Docket Nos. 50-338
and 50-339

SUBJECT: ISSUANCE OF AMENDMENT NO. 10 TO FACILITY OPERATING LICENSE NO.
NPF-4 - NORTH ANNA POWER STATION, UNIT NO. 1

License No. NPF-4
Amendment No. 10

SAFETY EVALUATION REGARDING STRUCTURAL INTEGRITY OF THE
REACTOR COOLANT PUMP SUCTION ELBOW SPLITTER,
NORTH ANNA UNIT 1

Figure 1

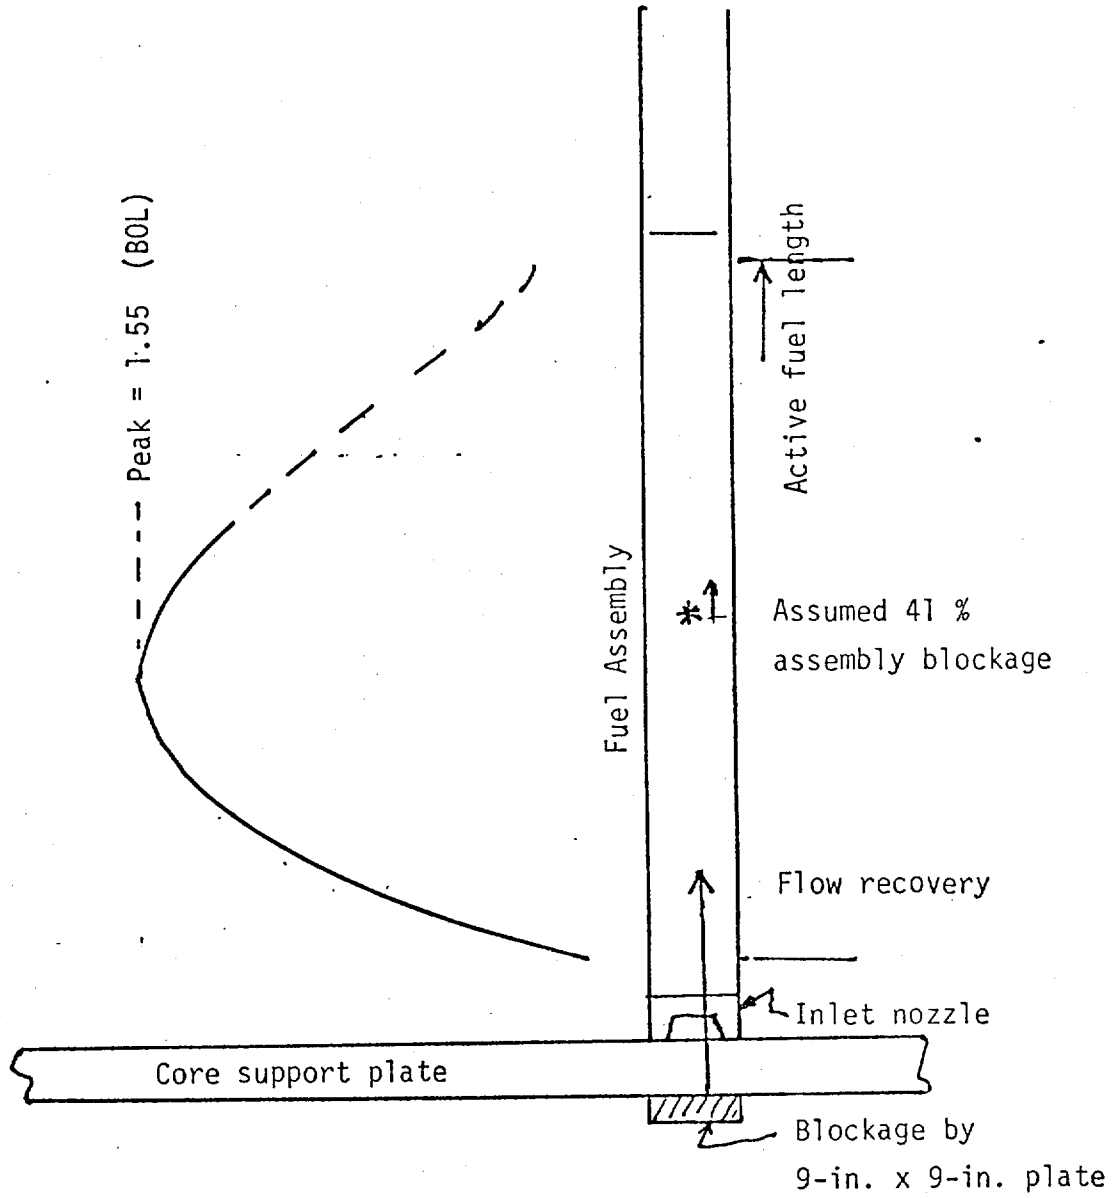
The flow splitter plate under consideration is installed in a 31-inch, 90 degree elbow in the reactor coolant pump suction. From a consideration of pump geometry and the fracture characteristics of the failed flow splitter plate, a range of fragment sizes was established by the licensee. The largest piece which could pass through the pump was estimated to be nine

The potential consequences of fragments in the estimated size range are (1) pump damage sufficient to create a reduction in loop flow, (2) damage to reactor vessel internals and instrument tubing should the flow splitter plate fragments manage to impact them and (3) the occurrence of flow blockage at various locations in the reactor vessel.

With respect to the reactor coolant pump, we have determined that if the largest postulated piece of failed flow splitter plate passes through the pump, the most likely result would be impeller key failure with loss of pump flow. Deformation of the impeller and diffuser vanes, most probably without fracture of these parts, would be anticipated. Abnormal pump shaft bending loads are to be expected. However, the shaft deflection resulting from these loads would alert plant operators via the installed reactor coolant pump shaft displacement monitoring system to stop the pumps before shaft failure occurs. Based on the above, we conclude that a technical specification is required which will require the licensee to shut down the plant and nondestructively examine all flow splitter plates

One consideration is the fuel rod behavior effect of coolant flow blockage, either within the coolant channels of a fuel assembly or in the reactor vessel lower internals. The licensee has considered a flow splitter plate piece simultaneously covering four lower core plate flow holes directly below a fuel assembly. Separate consideration was given to a smaller piece entering one of the core plate flow holes. The licensee has referenced the results of analyses provided on the "Standard Reference System Design RESAR-3S, Westinghouse Electric Corporation Safety Analysis Report". For that design it was predicted for complete blockage of the fuel assembly inlet nozzle that full flow recovery would occur about 30 inches downstream of the blockage. For an assumed 41 percent blockage occurring in the axial center of a fuel bundle, flow recovery was predicted to take place four to five inches beyond the blockage. This is illustrated schematically in Figure 1 (attached). Also illustrated on Figure 1 is an anticipated axial power shape at beginning of life (1.55 cosine skewed toward the bottom of the core by a -20 percent axial offset). Under these conditions the areas of reduced flow occur in a region of less than maximum peaking factor.

With respect to the inservice inspection program for the flow splitter plates, we have determined on the basis of our review that the licensee's proposed inservice inspection program for the flow splitter plates is unacceptable. Therefore, we are incorporating in the North Anna Unit 1 Technical Specifications an inservice inspection program consisting of the following:

- (1) Ultrasonic examinations of the elbows containing the flow splitter plates shall be conducted at each refueling outage for all loops.

- (2) The ultrasonic examinations shall be performed using the method developed and calibrated using the large flaws in North Anna Unit 2. The details of the examination are contained in Procedure 1-TP-1, "Ultrasonic Test Procedure for Examining Splitter Plates in Steam Generator-to-Pump Elbows North Anna Power Station Unit 1." The applicability of the procedure was demonstrated to IE Regional Office II personnel, who witnessed the testing and concluded the procedure is adequate to detect large cracks similar to those in North Anna Unit 2.
- (3) Reports of the examination results will be submitted to the NRC for review. The report should contain a determination regarding the growth of any existing flaws in the structure and identification of any new flaws that might have occurred in the interim service period.
